Access Compliance Report
Public Rights-of-Way
(Curb Ramps)

Intersection ID: 19682	Main Street: FLODDEN_FIELD_CT	Cross Street: YORKDALE_DR	Location:	SE
ADA ID: 3A91A20B806B	Ramp Type: PerpDiag	Initial Pass/Fail: Fail	Overall Compliance: No	Severity Score: 12.5

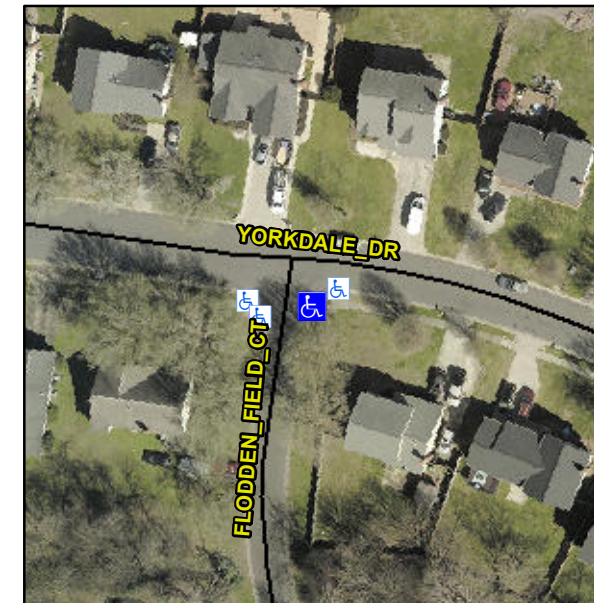
Not Found, R304.5.3

Compliance	Description	Data	Compliance	Description	Data
N/A	Ramp Length (in)	93.0	Yes	Ramp Slope (%)	7.7
Yes	Ramp Width (in)	66.0	No	Ramp XSlope (%)	5.9
N/A	Flare Type LT	N/A	N/A	Flare Type RT	N/A
N/A	Flare Slope LT (%)	N/A	N/A	Flare Slope RT (%)	N/A
N/A	Flare Traversable LT?	N/A	N/A	Flare Traversable RT?	N/A
N/A	Landing Length (in)	N/A	N/A	DWS Provided?	N/A
N/A	Landing Width (in)	N/A	N/A	DWS Contrast?	N/A
N/A	Landing Slope (%)	N/A	N/A	DWS Length (in)	N/A
N/A	Landing X Slope (%)	N/A	N/A	DWS Full Width?	N/A
N/A	Landing Curb? (Y/N)	N/A	N/A	DWS Offset (in)	N/A
N/A	Shared Landing?	N/A			
N/A	Gutter Ponding?	N/A	N/A	Gutter Slope (%)	N/A
N/A	Gutter Lip Ht (in)	N/A	N/A	Gutter X Slope (%)	N/A
N/A	Painted X Walk1?	No	N/A	Painted X Walk2?	No
	X Walk 1 Direction	To N		X Walk 2 Direction	To W
N/A	X Walk 1 Width (in)	N/A	N/A	X Walk 2 Width (in)	N/A
	X Walk 1 Slope (%)	6.8		X Walk 2 Slope (%)	2.3
	X Walk 1 X Slope (%)	2.3		X Walk 2 X Slope (%)	5.2

Remove & Replace Curb Ramp With Two New Directional Ramps or Equivalent.
